PROJECT REVIEW REPORT

Project ID	2401
Project Name	<i>Restoration of Degraded Lands in Sierra Leone</i>
Program(s)	VCS
Verification Period	<i>16 May 2016 to 10 January 2020</i>
Project Proponent	<i>Miro Forestry Developments Limited</i>
Methodology	<i>AR-ACM0003 A/R Afforestation and reforestation of land except wetlands, v2.0</i>
Sectoral Scope(s)	<i>14. AFOLU (Agriculture, Forestry and Other Land-Use)</i>
Validation/Verification Body (VVB)	AENOR

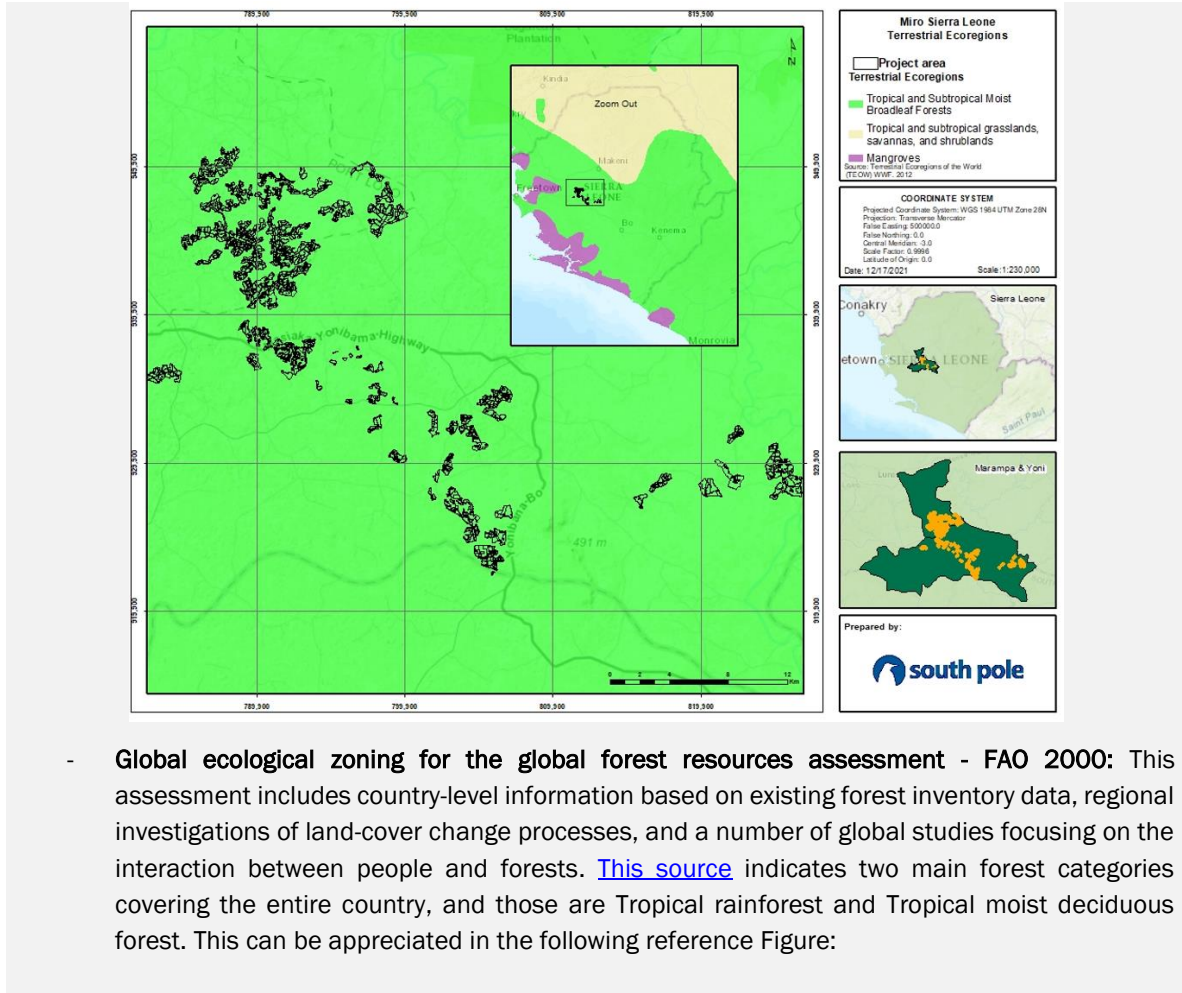
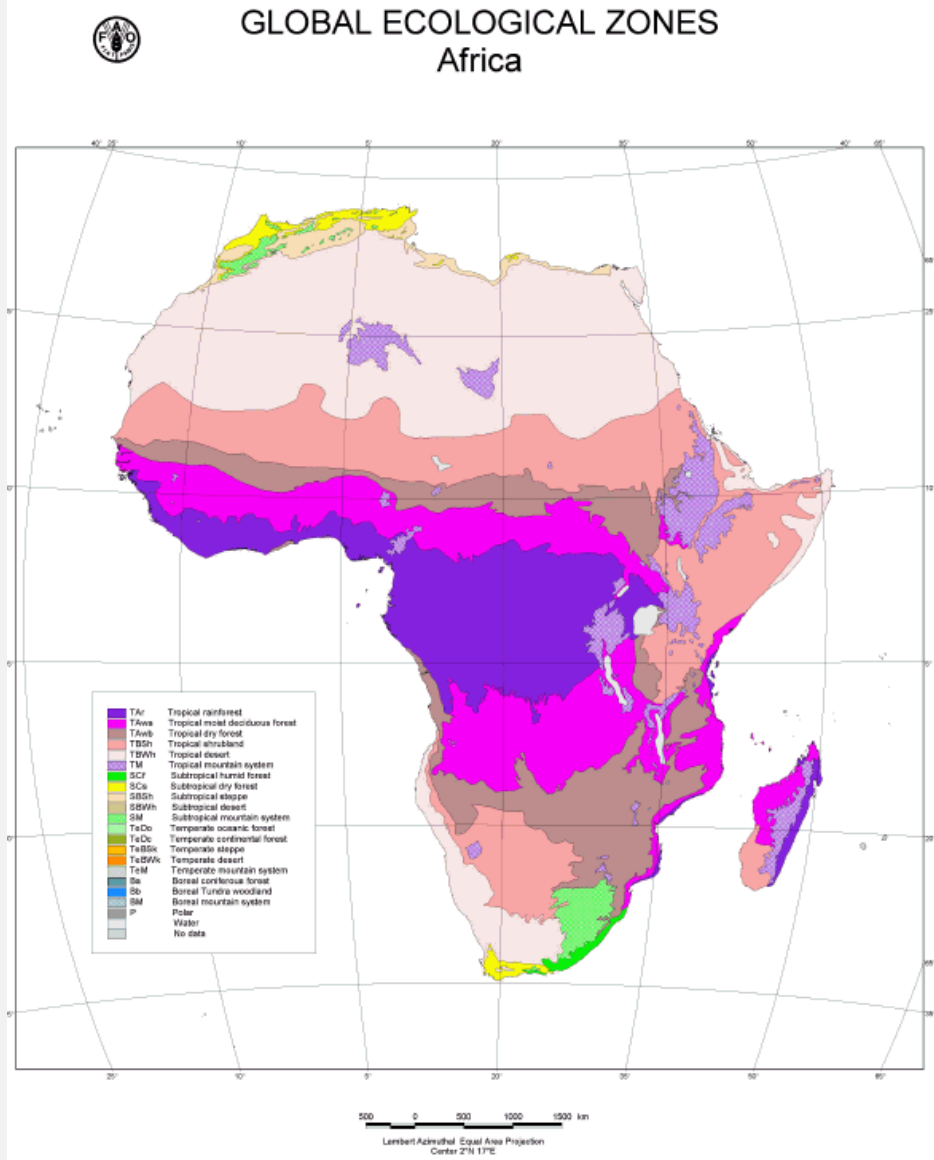
Section 3.2.4 of the VCS Standard, v4.1 states that for ARR projects “the project area shall not be cleared of native ecosystems within 10 years of the project start date”. As the majority of the project area is native grassland, the project proponent is requested to clarify in Section 4.1 whether any clearing of native grassland took place in order to facilitate planting.

The majority of the project area baseline is indeed grassland, as indicated in the eligibility analysis of the PDD. However, this type of land cover is the result of historical deforestation and degradation of the area caused by agricultural and charcoal production. This statement can be supported by the Environmental and Social Impact Assessment ESIA study, submitted along with the supporting documentation.

In this study, it is indicated that there is a very limited tree cover over the project area, save for sporadic sacred groves near villages, the entire area has suffered heavily from slash and burn agriculture and charcoal production for local consumption as well as for sale in the local cities.

“For these reasons, and originally to profit from high-value indigenous hardwood sales, Sierra Leone has suffered some of the worst deforestation in West Africa, many estimating it to be over 90% within the last 100 years.” In the same study, it is stated in section 4.6.3 Vegetation, “About 75% of the project area is covered by farm bushes, with vast areas characterized by thick secondary undergrowths, believed to have been part of the Tropical Rainforest, but having been subjected to clearing, burning and tree cutting for several years”

- Terrestrial Ecoregions of the World (WWF 2012): According to this source, the project area falls completely in the ecoregion Western Guinean Lowland Forest also known as Tropical and Subtropical Moist broadleaf forest, as presented in the next figure:

Considering the elements referenced above, it can be concluded that the grasslands in the baseline scenario are the result of natural forest degradation and do not correspond to a grassland natural ecosystem. Thus, the project complies with Section 3.2.4 of the VCS Standard, v4.1 states that for ARR projects “the project area shall not be cleared of native ecosystems within 10 years of the project start date”.

The explanation provided by the VVB and the supporting evidence provided by the project proponent and included in the updated documents demonstrates that the project has not cleared native grasslands for planting activities. This finding is closed.
